WANG MANUFACTURING
TEST PROCEDURE

2200 SERIES DS DPU BOARD

2 IN-SYSTEMS TEST

**2200 SERIES DS DPU BOARD.
IN-SYSTEMS TEST (210-8826-A)**

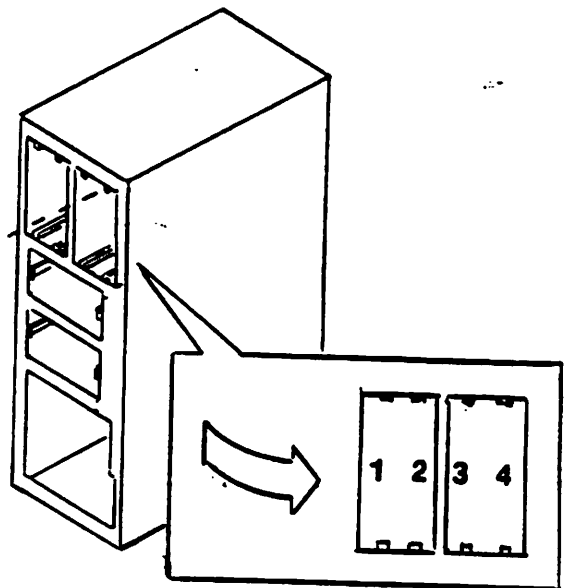
THIS VISUALLY IS OUT OF PROPORTION TO CABINET. I ASSUM THIS IS FRONT VIEW IF FRONT VIEW SHOW MORE CABINET ON RIGHT THEN LEFT.

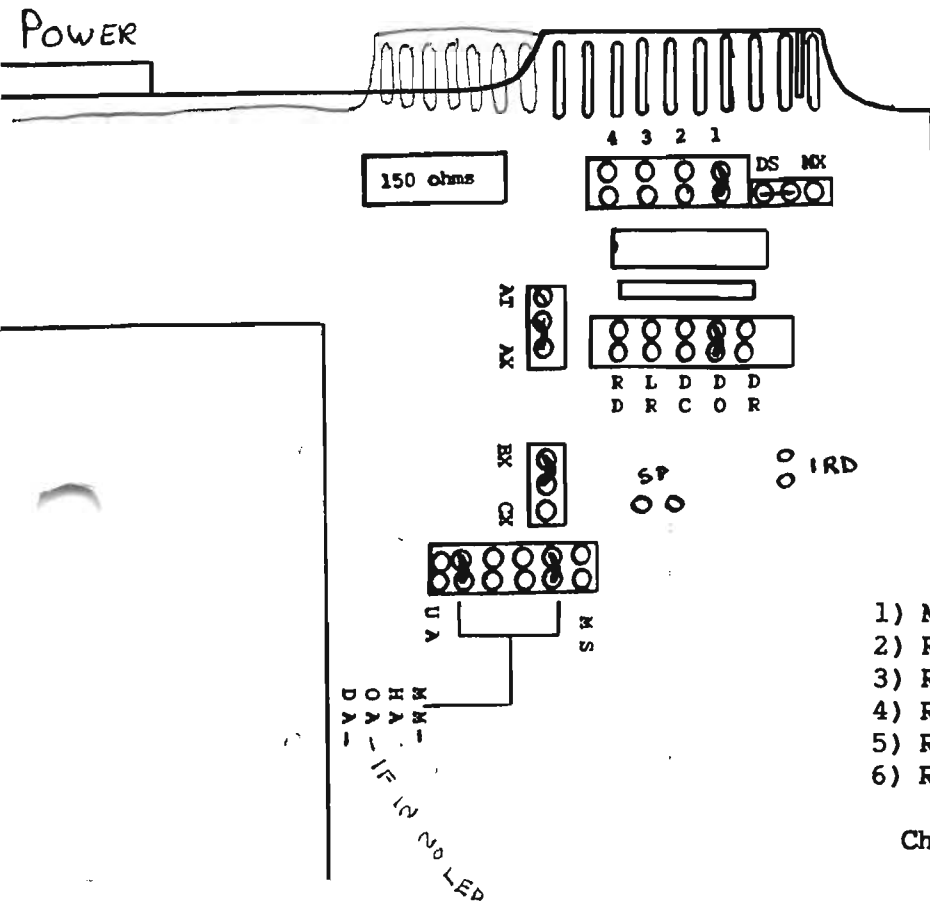
VISUAL AIDS: Amber led - no snowflake / also: PCB IS 1/2 THE NORMAL SIZE.

- 1) Move jumper from "DS 2" to "DS 1"
- 2) Remove "DR" jumper
- 3) Remove "SP" jumper
- 4) Remove "DC" jumper / install "DO" jumper
- 5) Remove "AT" jumper / install "AX" jumper
- 6) Remove "CX" jumper / install "BX" jumper
